OICA inputs for PMP meeting on 25th of March 2025

Version 24.03.2025

Table of contents (TF3 & TF4)

Results and Potential Limits of IPDW & IPDR

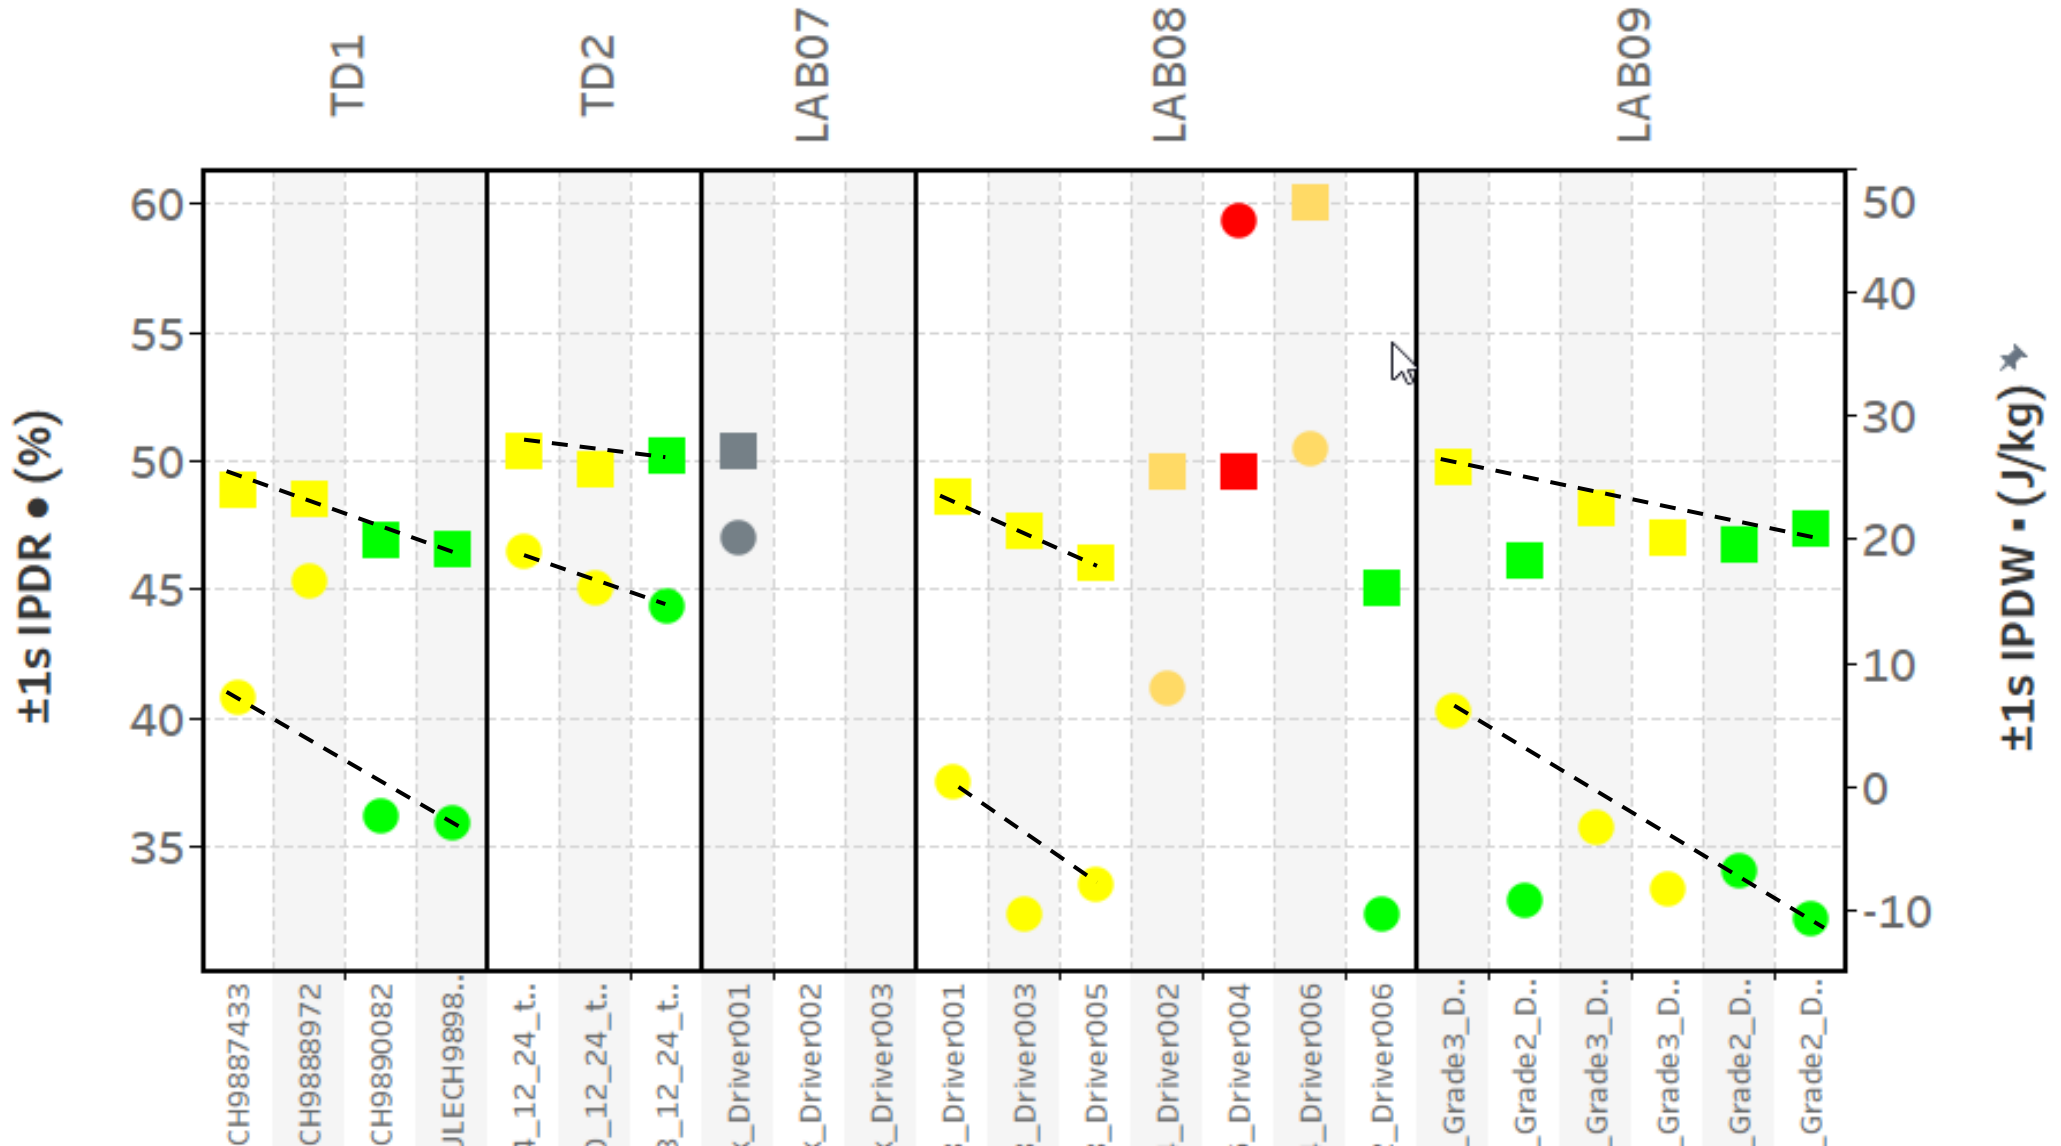
- 12 Labs participated in the OICA Round Robin for Quality Criteria.
- IPDW & IPDR successfully detect the different driving/braking quality.
- Limit suggestion: IPDR = 45 %, IPDW = 30 J/kg

Insufficient RMSSE-Criterion

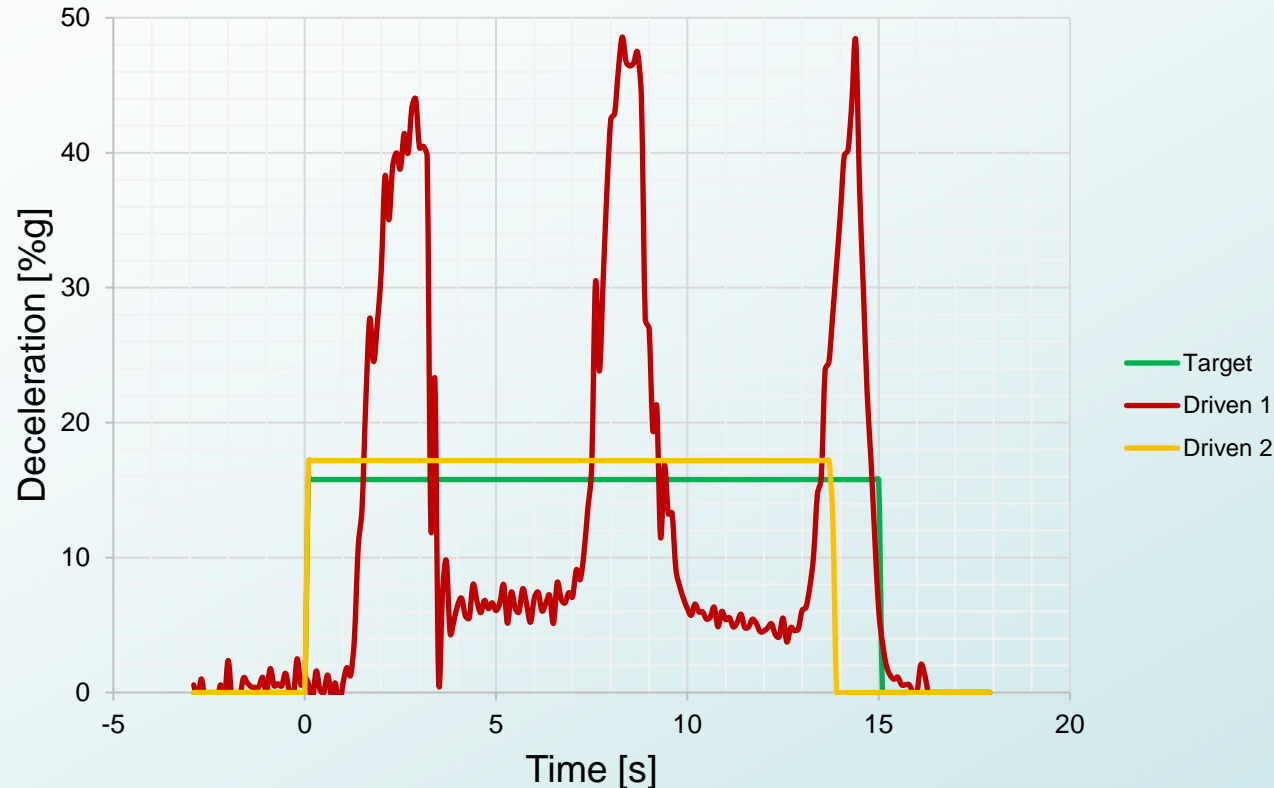
- Same result for absolutely different driving characteristic

Reason: The average deviation of a small constant deviation is similar to a large oscillating deviation.

➤ Same RMSSE results for absolutely different driving styles

Insufficient RMSSE-Criterion

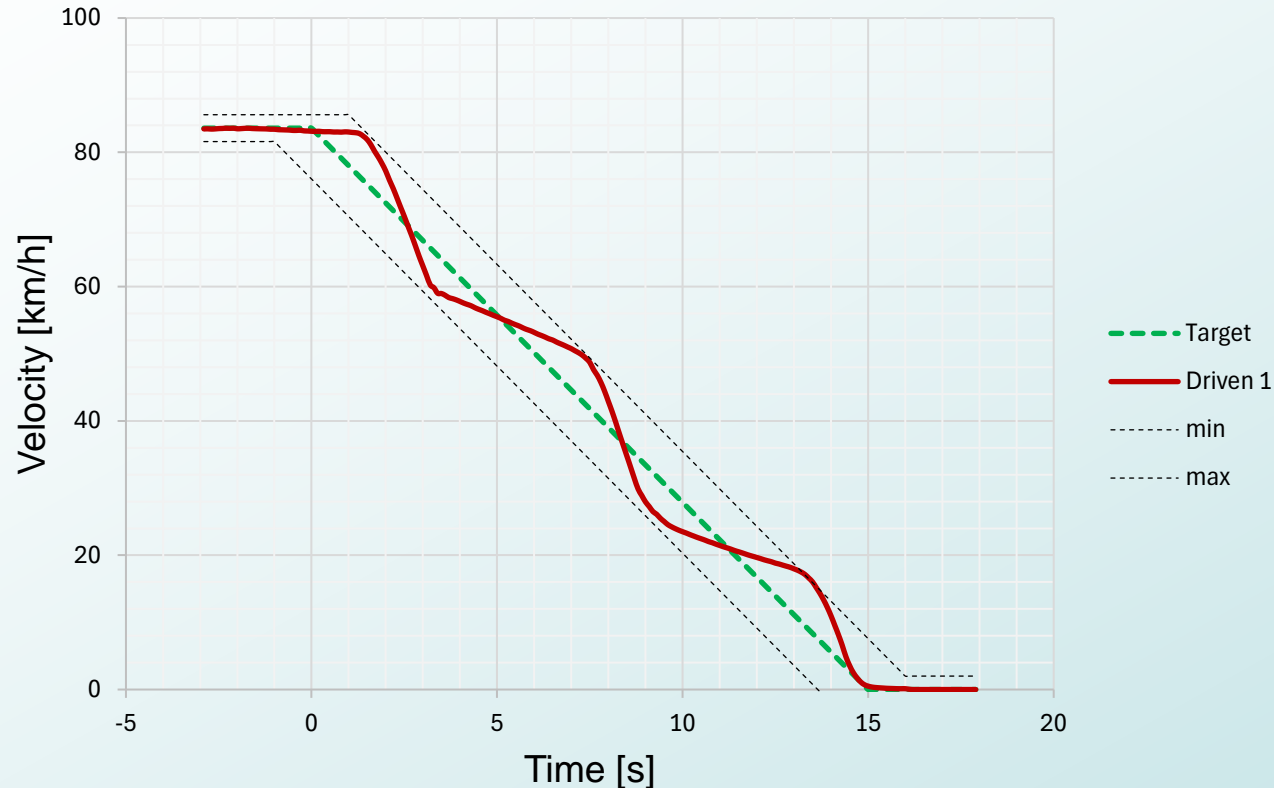
- Same RMSSE result but 2-3x higher deceleration and thus 2-3x higher braking force/torque
- RMSSE not sufficient

Insufficient IWR-Criterion

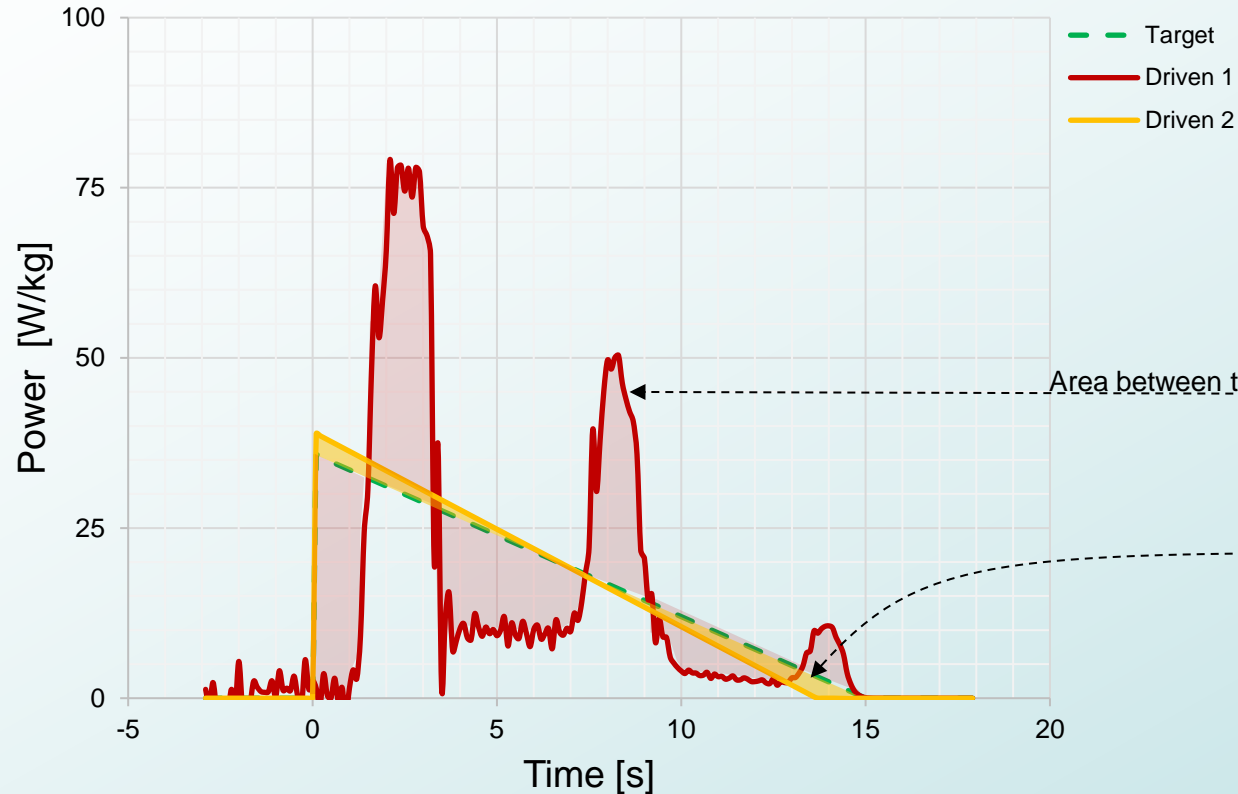
- IWR does not detect a deviation
- Allowed (GTR15): $-2.0\% < IWR < 4 \%$

Reason: Inertial work actually depends only on the start and end velocity (difference of kinetic energy).

➤ IWR does not detect deviation as long as start and end velocity are matching the target.

New Criterion – Inertial Power Difference Work

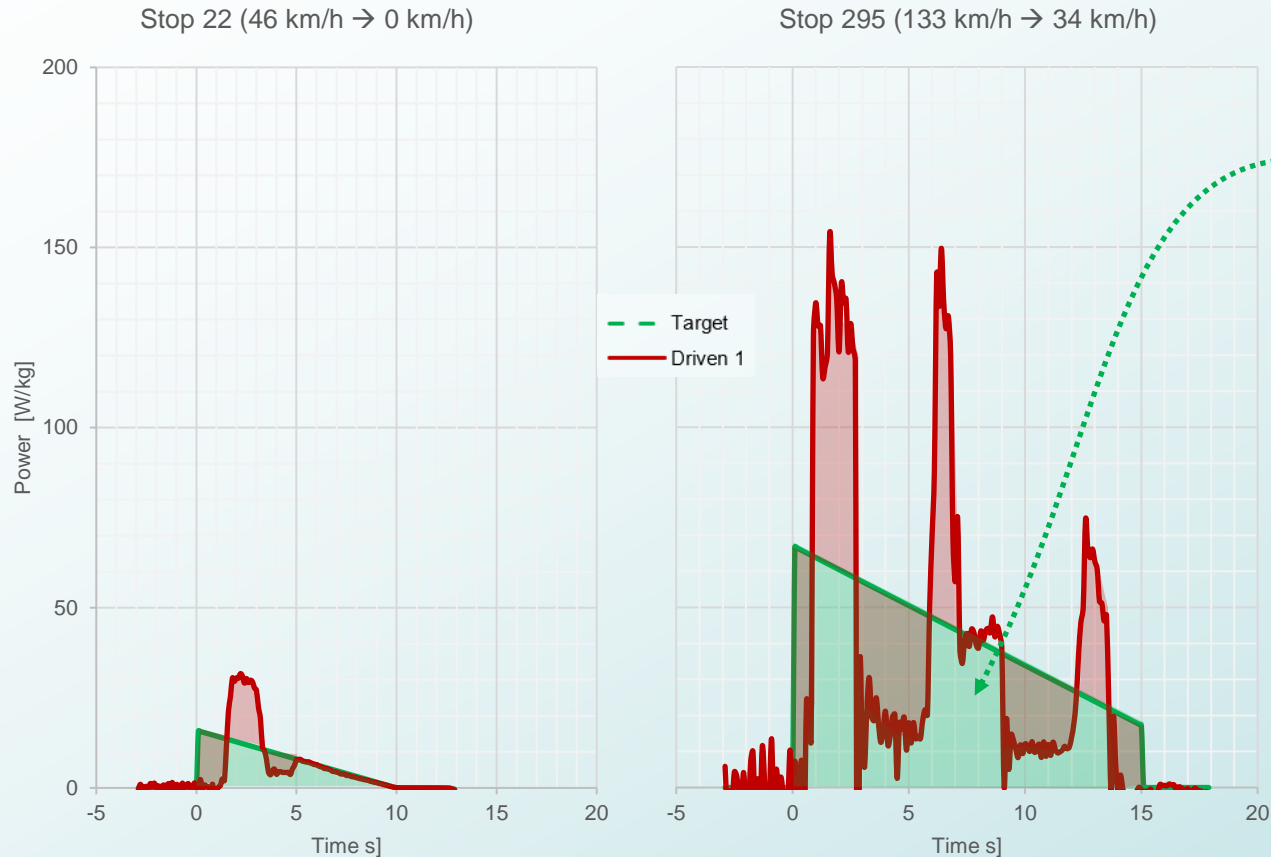
- Distinct difference between both profiles

➤ IPDW separates the different driving styles by a factor of ~10x.

Relevant Values of New Criteria

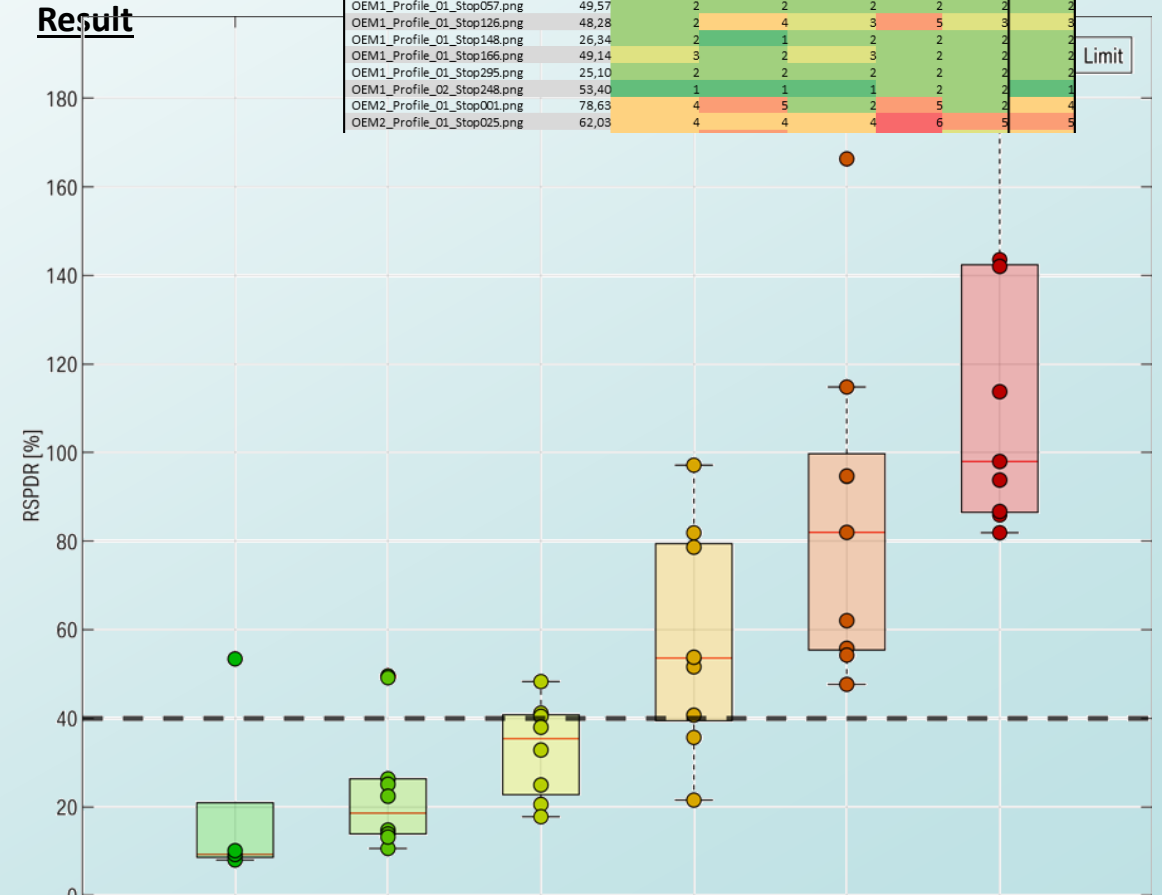
- RSPDR correlates good with average manual evaluation
- Allowed values for RSPDR might be in the range of 40%
